PROPOSED HOUSING DEVELOPMENT AT  
CROKE VILLAS, DUBLIN

**Stage 1 Quality Audit**

(Incorporating a DMURS Street Design Audit, and Audits  
of Accessibility, Cycling, Walking and Road Safety)

<b>Project Title</b>	Proposed Residential Development at Croke Villas, Dublin
<b>Project No.</b>	24050-02
<b>Client</b>	Malone O'Regan
<b>Document Title</b>	Stage 1 Quality Audit
<b>Document No.</b>	24050-02-001

**Figure 5.13 – Proposed Trees hiding Stop sign and Stopline at the bottom of ramp**

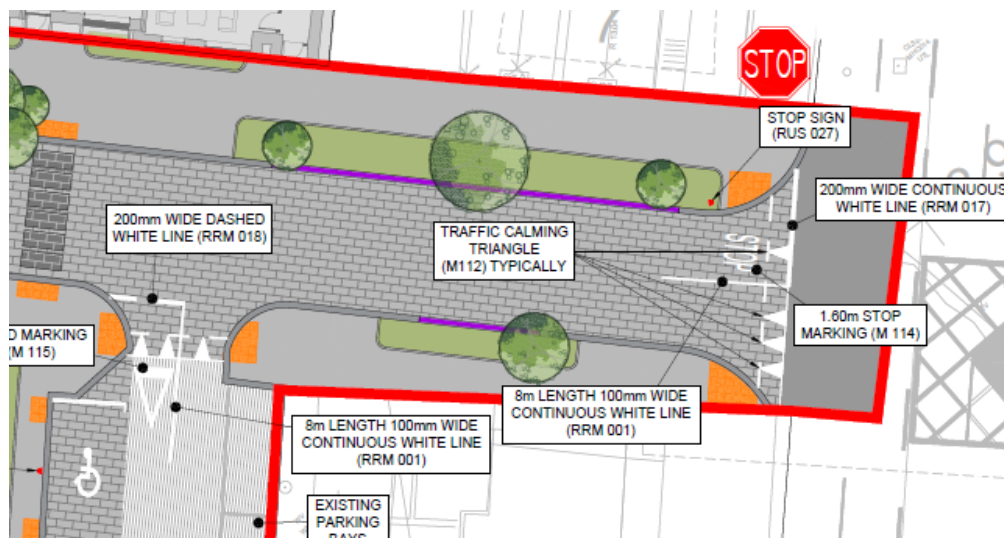
The stop sign warning in Figure 5.13 may not be visible to approaching motorists, due to the proposed trees. The may also may not see the Stopline which is at the bottom of the ramp on the raised carriageway and may be obscured from vision. This may cause vehicles to overshoot resulting in collisions.

Ensure full visibility of Stop sign and Stopline for all users an approach. Remove/relocate trees as required.

**Figure 5.14** – Proposed shared space at turning area

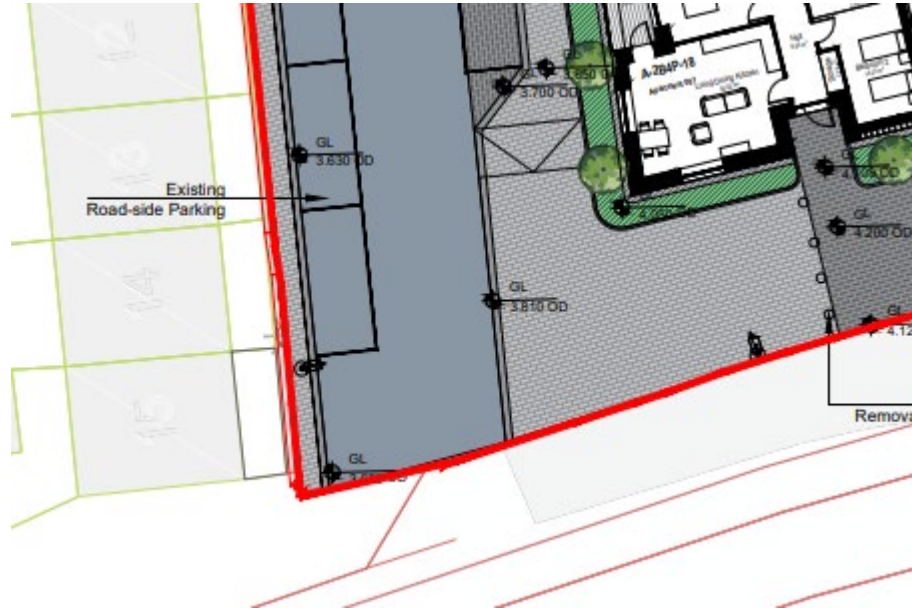
It is intended that the area on the east side of the cul-de-sac in the southwest corner of the development act as a shared space between vehicles turning and pedestrians travelling to and from the residential units. The use of this area as a shared space may increase collision risk particularly as it involves vehicles turning and reversing.

Provide a segregated footpath and vehicular turning area at this location.

**Figure 6.1** – Proposed Trees compromising intervisibility of pedestrians and motorist at crossings

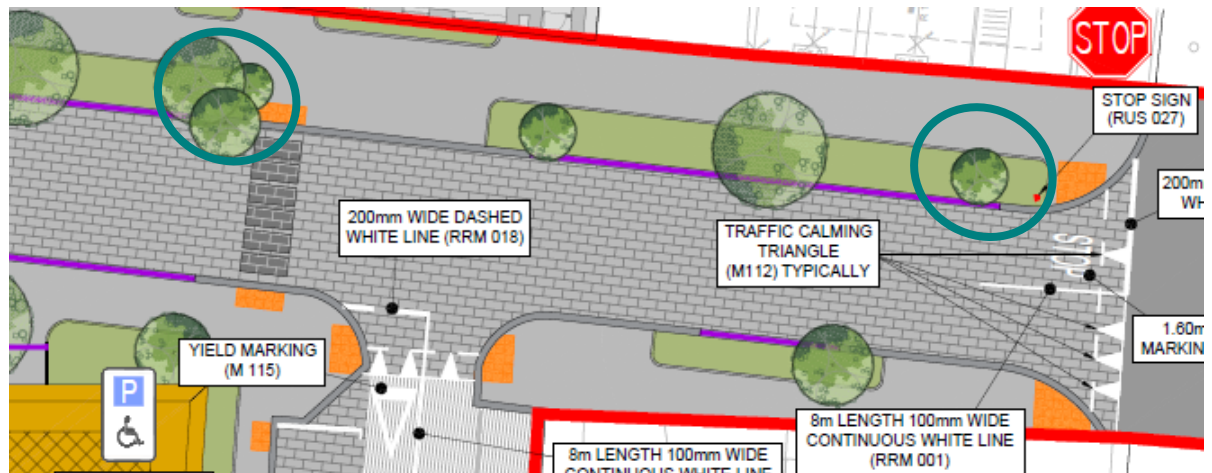
Inter-visibility between pedestrians and drivers at crossings in the proposed development may be significantly compromised by the proposed tree locations. This may increase the risk of collisions and pedestrian injuries at these locations because of trees including, but not limited to, those circled in Figure 6.1 and Figure 6.2.

Ensure adequate inter-visibility between pedestrians and drivers at priority crossings. Relocate trees as appropriate.

Figure 6.3 – Proposed Disabled Bay compromising intervisibility when occupied

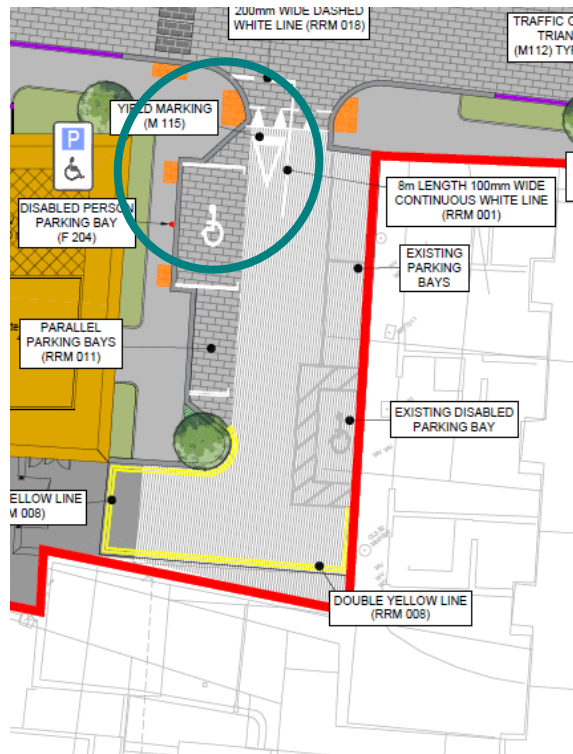
Inter-visibility between pedestrians and drivers at crossings in the proposed development may be significantly compromised by parked vehicles in the disabled bay (Figure 6.4). This may increase the risk of collisions and pedestrian injuries at this location.

Ensure adequate inter-visibility between pedestrians and drivers at priority crossings.

Figure 6.4 – Warning Sign Poles reducing effective width of footway

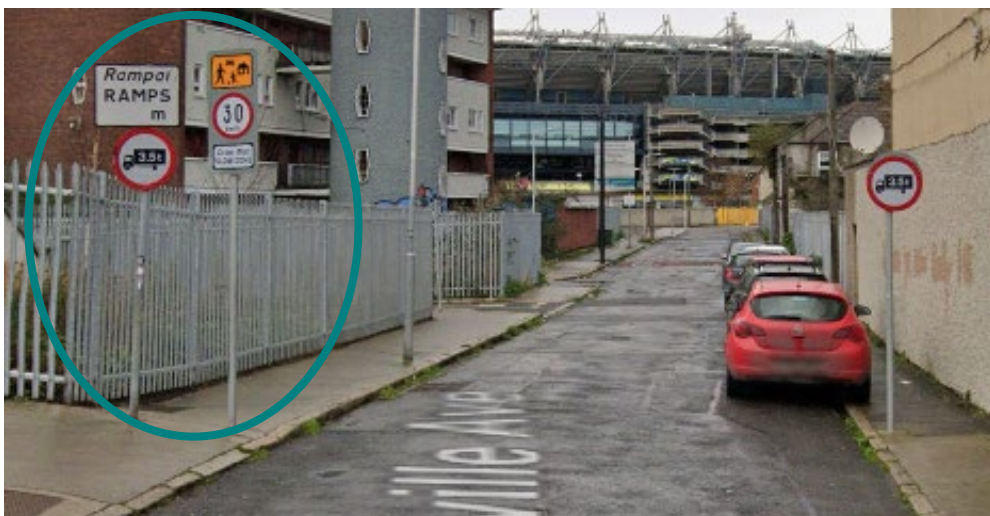
At the Sackville Ave / Ballybough Road Junction there are multiple warning sign poles in close proximity. This will reduce the effective width of the footway and the level of service of this footway (Figure 6.4).

Rationalise the amount of street clutter and street poles.

Figure 8.1 – Proposed disabled bay

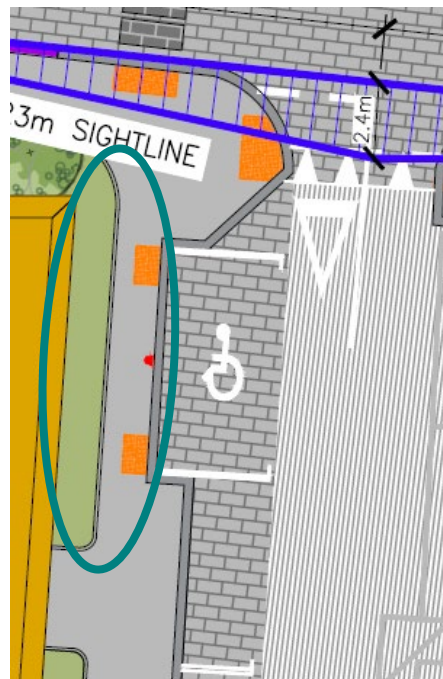
A proposed disabled bay (Figure 8.1 and Figure 8.2) shows conflicting information between drawings regarding how much footway space is between the edge and the building and how much will be grassed area. Inclusion of ramps recessed into the footway at this location may significantly reduce the effective width of the footway and post challenges for pedestrians with mobility impairments. The provision of tactile paving to access the disabled bay may also result in confusion for pedestrians with a vision impairment who may assume this is a pedestrian crossing. These pedestrians may then cross the street, meet a kerb with no tactile paving, and become disoriented.

Ensure adequate access routes around and adjacent to the disabled bays. Remove tactile paving from access ramps.

**Figure 8.3 – Existing disabled bay**

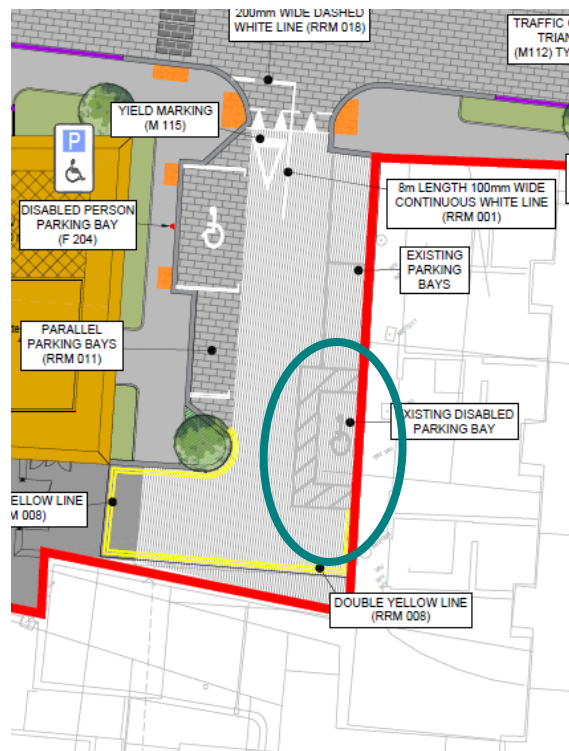
An existing disabled bay (Figure 8.3 and Figure 8.4) was observed to have tactile paving ramps down to access the disabled bay. This may result in confusion for pedestrians with a vision impairment who may assume this is a pedestrian crossing. These pedestrians may then cross the street, meet a kerb with no tactile paving, and become disoriented.

Remove tactile paving from access ramps.

Figure 8.5 – Proposed disabled bay

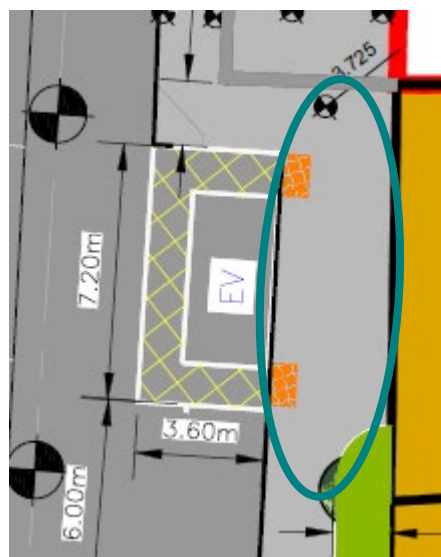
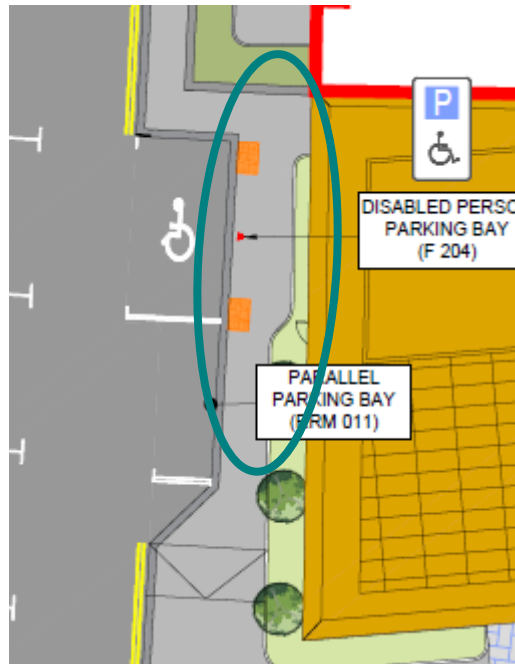
A proposed disabled bay (Figure 8.4 and Figure 8.5) shows conflicting information between drawings regarding how much footway space is between the edge and the building and how much will be grassed area. Inclusion of ramps recessed into the footway at this location may significantly reduce the effective width of the footway and pose challenges for pedestrians with mobility impairments. The provision of tactile paving to access the disabled bay may also result in confusion for pedestrians with a vision impairment who may assume this is a pedestrian crossing. These pedestrians may then cross the street, meet a kerb with no tactile paving, and become disoriented.

Ensure adequate access routes around and adjacent to the disabled bays. Remove tactile paving from access ramps.

Figure 8.6 – Ramps and steps with no tactile paving

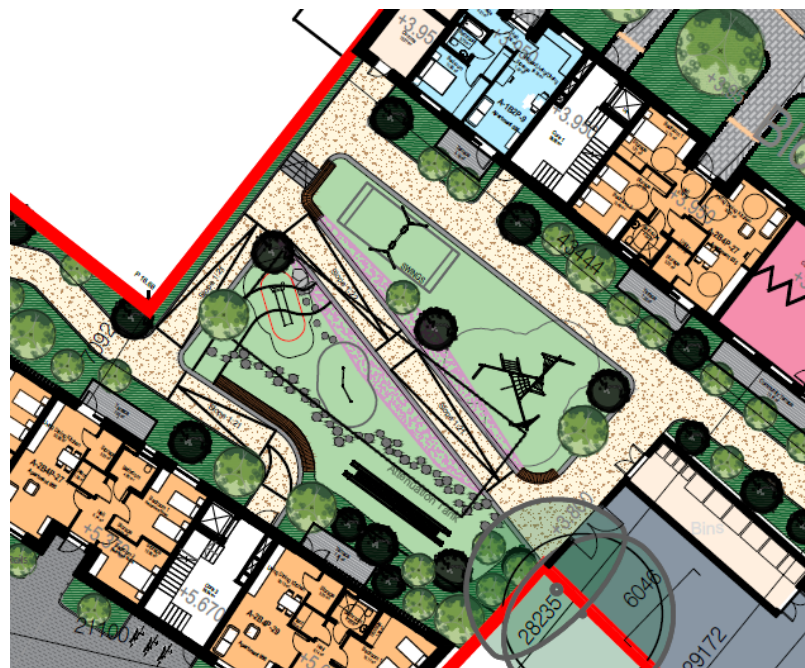
Proposed ramps and steps within the development courtyard area including, but not limited to, those in Figure 8.6, do not appear to feature railings or tactile paving. This means that users with mobility or vision impairments may struggle to navigate this area.

Ensure provision of tactile paving and railings at all locations as required.

**Figure 8.8 – Sackville Gardens Access**

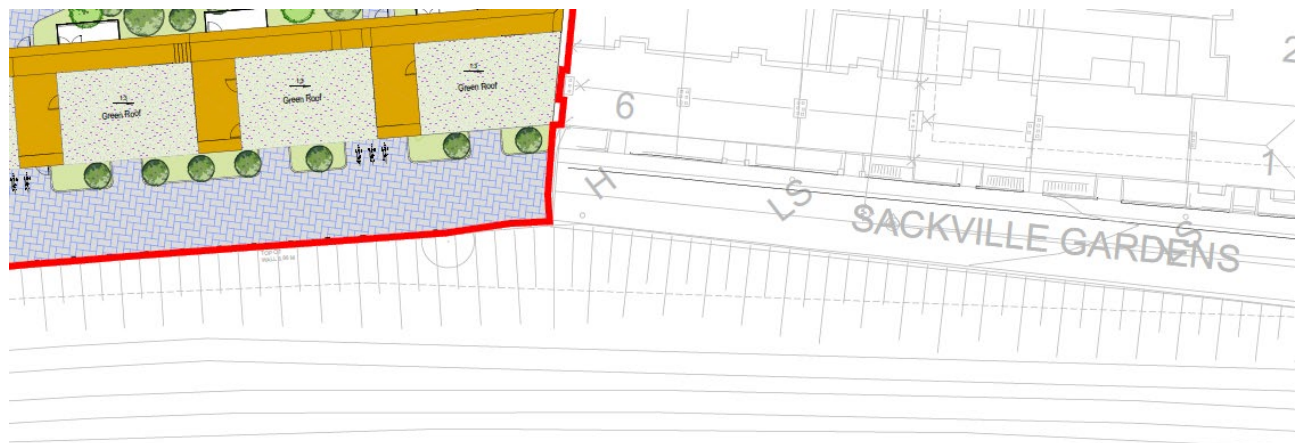
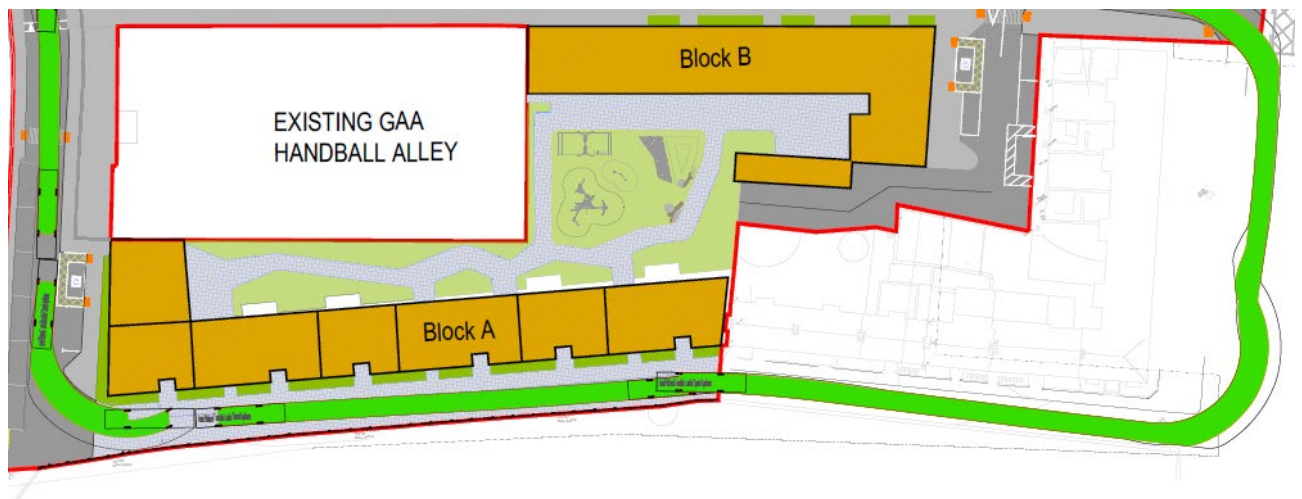
The proposed infrastructure appears to provide for a tie-in to Sackville Gardens (Figure 8.8 and Figure 8.9). It is not clear how the existing segregated roadway and footway on Sackville (Figure 8.10) will tie into the proposed shared space local street proposed. They may cause confusion for a pedestrian with a vision impairment and an increased likelihood of vehicles colliding with pedestrians.

This tie in should be redesigned to ensure continuity and clarity for pedestrians with vision and mobility impairments.
